STAFF RECOMMENDATION
2306 Sunset Place
June 16, 2021

Application: New Construction—Infill
District: Hillsboro-West End Neighborhood Conservation Zoning Overlay
Council District: 18
Base Zoning: RS7.5
Map and Parcel Number: 10415023000
Applicant: Chris Goldbeck
Project Lead: Melissa Baldock, melissa.baldock@nashville.gov

Description of Project: Applicant proposes to construct infill and an outbuilding on a vacant lot.

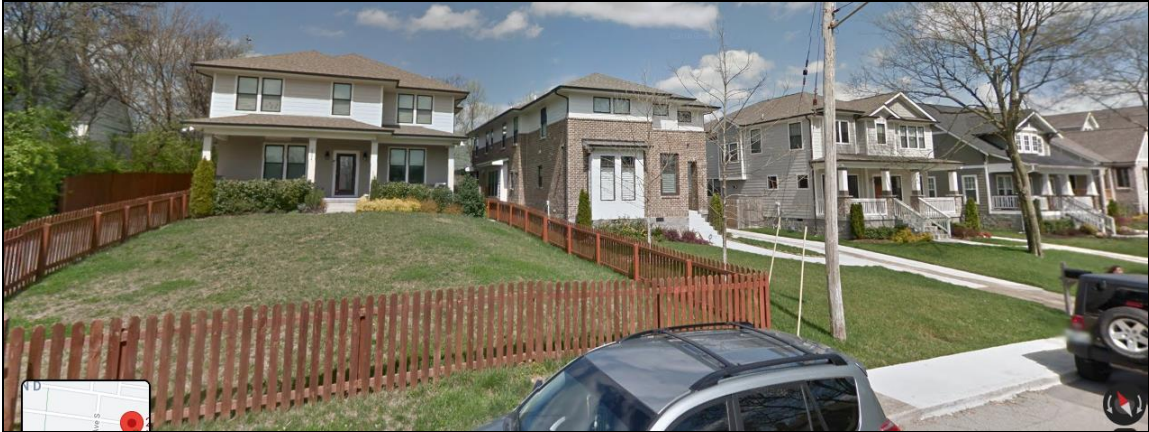
* The drawings show that there is just one, double-wide garage bay facing the street. Staff recommends that there be two different garage bays since they face the street.

With the condition that the garage have two separate garage bays and doors, staff finds that the proposed outbuilding meets Section II.B.1.h of the design guidelines.

SITE PLAN

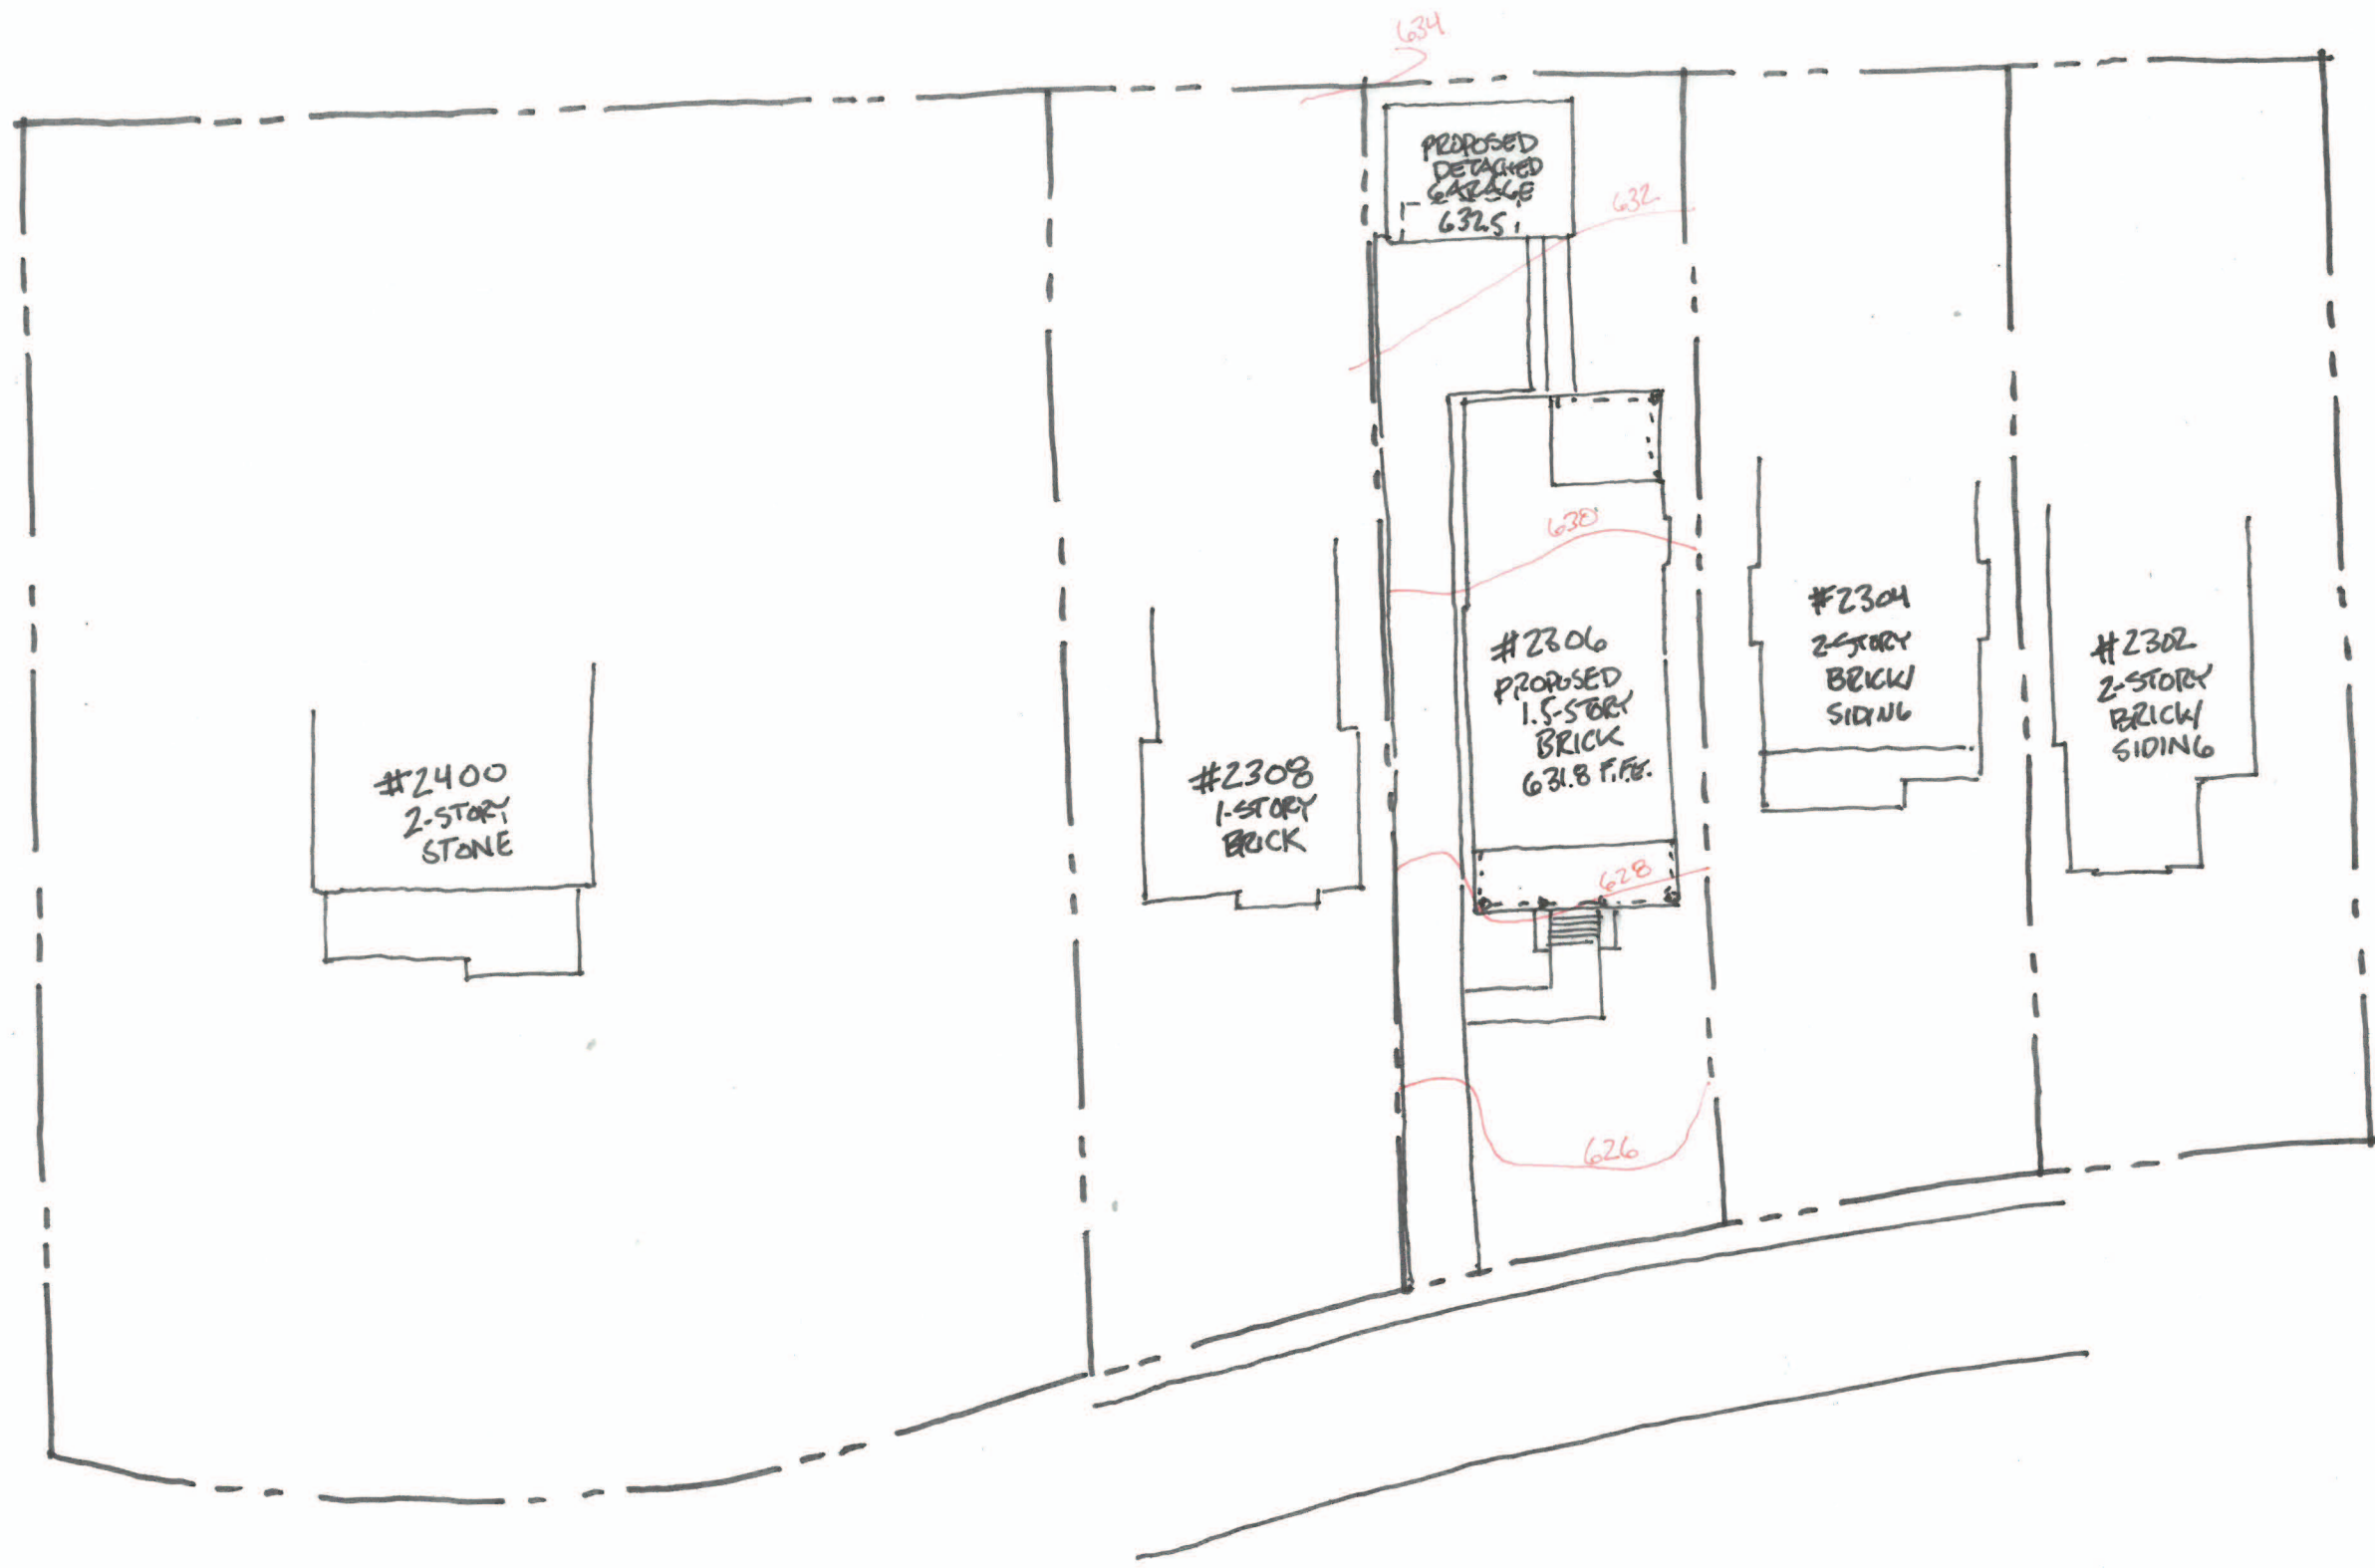
Setback & Rhythm of Spacing: The infill will meet all base zoning setbacks. It will be twelve feet (12') from the left side property line to allow for a side driveway and five feet (5') from the right side property line. It will be approximately fifty feet (50') from the rear property line, and there will be twenty-five feet (25') between the rear of the infill and the outbuilding.

Orientation: The infill is oriented to Sunset Place, with a nine foot, seven inch (9’7”) deep full width front porch. The lot does not have an alley; therefore, the applicant will have an eleven-foot (11’) wide side driveway that extends to the rear of the house. The front walkway to the porch is drawn as leading to the side driveway. Staff recommends that the walkway also lead to the sidewalk along Sunset.

With the condition that the walkway also extend to the sidewalk along Sunset Place, staff finds that the infill’s orientation meets Section II.B.1.f. of the design guidelines.

FRONT ELEVATION
SCALE: 1/4" = 1'-0"

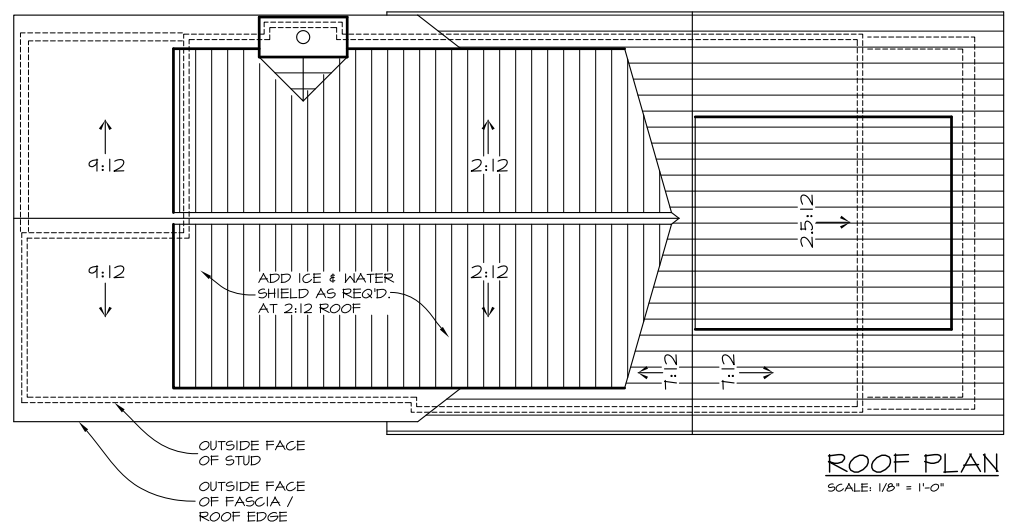
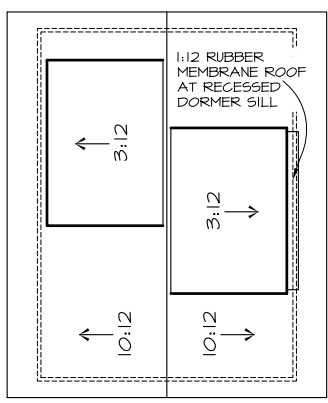
Height & Scale: The infill will be one-and-a-half stories in scale, with a maximum height of twenty-four (24') above the finished floor. The lot slopes up from the front to the back, so the foundation height varies. At the front, the foundation will have a height of three feet (3'), and it will decrease in height as it goes back. It will have an eave height of approximately nine feet (9') above the foundation. These heights and scales are similar to the historic context where there is a mixture of one and one-and-a-half story historic houses, one large two story house, and several two-story recent infills that are outside of the overlay. Specifically, historic houses in the immediate vicinity have heights ranging from twenty to forty-five feet (20'-45'), with most houses ranging from twenty-one to twenty-five feet (21'-25') tall and with eave heights between eight and ten feet (8'-10').

The front setback is appropriate for the historic context. The houses to the right are non-contributing and outside the overlay, so staff is primarily concerned with how this house relates to the historic house next door at 2308 Sunset. The front wall of the infill will be at least five feet (5') behind the main front wall of the house at 2308 Sunset and will be six feet, six inches (6'6") behind the projecting gable bay. However, the front of the porch will be slightly in front of the front walls of the house at 2308 Sunset; it will be forward four feet (4') from the main wall and just two feet (2') from the projecting gabled bay. Staff finds this front setback to be appropriate because part of the infill that is just slightly forward of the historic house next door is an open porch and not a solid wall.

1. The finished floor height be consistent with the finished floor heights of the adjacent historic houses, to be verified by MHZC staff in the field;
2. Staff approve all windows and doors, masonry (brick) samples, the metal roof color and specification, the roof shingle color, and the driveway and walkway materials prior to purchase and installation;
3. The front walkway extend from the porch to the sidewalk along Sunset Place;
4. The outbuilding have two separate garage bays rather than one double-wide bay; and,
5. The HVAC be located behind the house or on either side, beyond the mid-point of the house, and utility meters shall be located on the side of the building, within 5' of the front corner. Alternative mechanical and utility locations must be approved prior to an administrative sign-off on building permit(s).
